# UNITED STATES PATENT AND TRADEMARK OFFICE

APPLICATION NO.	FILING DATE	FIRST NAMED INVENTOR	ATTORNEY DOCKET NO.	CONFIRMATION NO.
10/717,003	11/19/2003	Tomasz Slawinski	224945	7592

## Office Action Summary

APPENDIX A (Exploded view of Fig. 1 of U.S. Pat. No. 4,679,765)

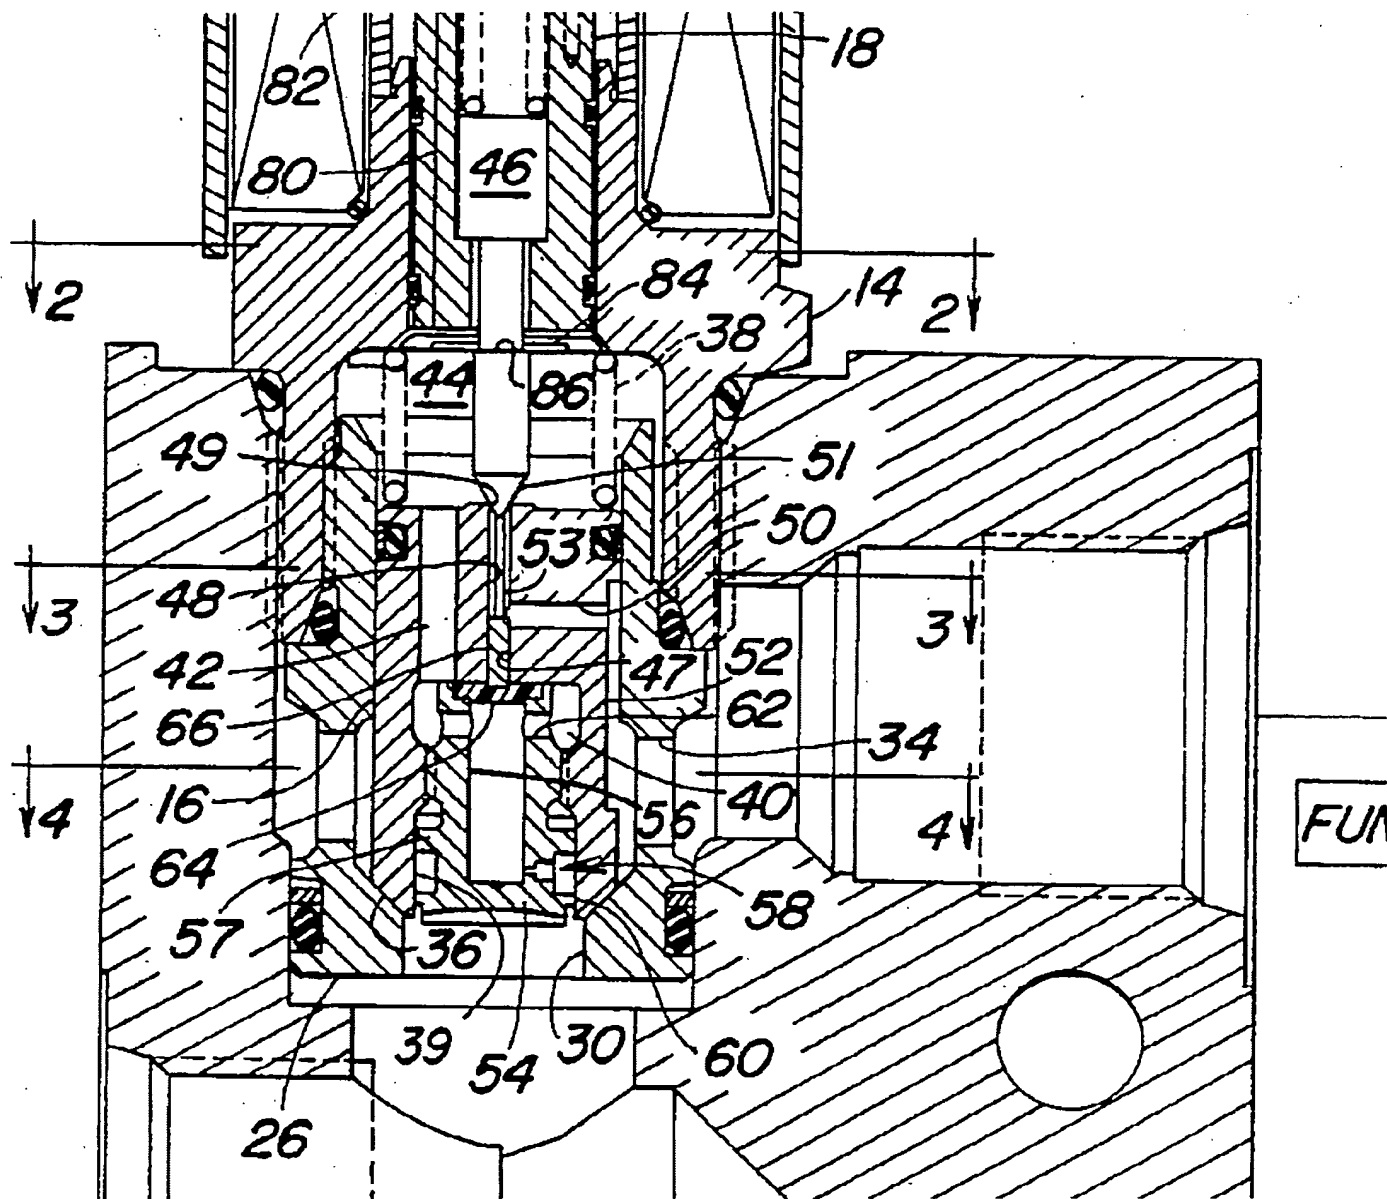
The patent to Kramer et al ('765), in figure 1, (an exploded view is provided as Appendix A) discloses a "filter (read at plug 54) for a valve (main spool 16), the valve including a bore (39) for receiving the filter (54) and an orifice (58) for accommodating a fluid flow therethrough, the filter (54) comprising: an entrance head (at land 60), the entrance head configured to be in predetermined spaced relationship with the bore (36) of the valve (16) when disposed therein to define a filter entrance (see in particular column 3, lines 46-51), the filter entrance being sized to prevent particles of a predetermined size from entering the filter entrance; and a body portion (the apparent annular channel which is immediately downstream of land 60 and the gap formed between land 60 and bore 36) cooperating with the bore (36) to define a fluid passage, the fluid passage (e.g. annular channel) having an exit port which is communicable with the orifice (at 58)" as recited in claim 1.

Regarding claim 2, in Kramer et al ('765), "the body portion includes a relief element (e.g. the annular area forming the annular channel) for defining the fluid passage" as recited.

Regarding claim 5, in Kramer et al ('765), "the body portion includes a seal ring" read at the upper land 57 and the threaded sealed reception of plug 54 within bore 36, as recited.

Regarding claim 6, in Kramer et al ('765), "the body portion includes a first section (at the apparent annular channel) at least a portion of which is smaller than the entrance head (at land 60) to define the fluid passage" as recited.

Regarding claim 7, in Kramer et al ('765), "the body portion includes a second section (above land 57) adjacent to the first section, the second section being smaller than the first section to define a step (e.g. the upper surface of land 57) therebetween" as recited.

Regarding claim 8, in Kramer et al ('765), "the exit port (communicating with orifice 58) is disposed in the body portion" as recited.

Regarding claim 9, in Kramer et al ('765), "the body portion includes a hole (e.g. orifice 58) in communication with the exit port" as recited.

Regarding claim 10, in Kramer et al ('765), "a mounting flange" is read at the very lowest thread on the exterior of the plug 54 in threaded contact with the interior bore 36.

Regarding claim 12, in Kramer et al ('765), the body portion defines the orifice (58)" as recited.

Regarding claim 13, the patent to Kramer et al ('765) discloses a "valve comprising: an input port (30) for connection to a pressure source (pump 32) to develop a fluid flow; a bore (36) in communication with the input port; an orifice (58) for accommodating the fluid flow therethrough, the orifice (58) disposed in the bore; and a filter (plug 54) disposed in the bore (36), the filter (54) including an entrance head (at land 60) and a body portion (immediately downstream of land 60), the entrance head (60) in predetermined spaced relationship with the bore (36) of the valve to define a

filter entrance (see column 3, lines 46-51), the filter entrance being sized to prevent particles of a predetermined size in the fluid flow from entering the filter entrance, the body portion cooperating with the bore to define a fluid passage (at the apparent annular channel immediately downstream of land 60), and the fluid passage having an exit port which is communicable with the orifice (58)" as recited.

Regarding claim 19, in Kramer et al ('765), "the body portion of the filter (54) includes a relief element (e.g. the area forming the annular channel) for defining the fluid passage" as recited.

Regarding claim 21, in Kramer et al ('765), "the body portion of the filter (54) includes a seal ring (read on the upper land 57 and the threaded sealed reception of the plug 54 within the bore 36 of the valve 16" disposed in sealing engagement with the bore (36)" as recited.

Regarding claim 22, in Kramer et al ('765), "the body portion of the filter (54) includes a first section (at the apparent annular channel) at least a portion of which is smaller than the entrance head (at land 60) to define the fluid passage" as recited.

Regarding claim 23, in Kramer et al ('765), "the body portion of the filter (54) includes a second section (above land 57) adjacent to the first section, the second section being smaller than the first section to define a step (e.g. the upper surface of land 57) therebetween" as recited.

Regarding claim 24, in Kramer et al ('765), "the exit port (communicating with orifice 58) is disposed in the body portion of the filter, and the body portion includes a hole (e.g. orifice 58) in communication with the exit port" as recited.

Regarding claim 27, in Kramer et al ('765), "the body portion of the filter (54) defines the orifice (58)" as recited.
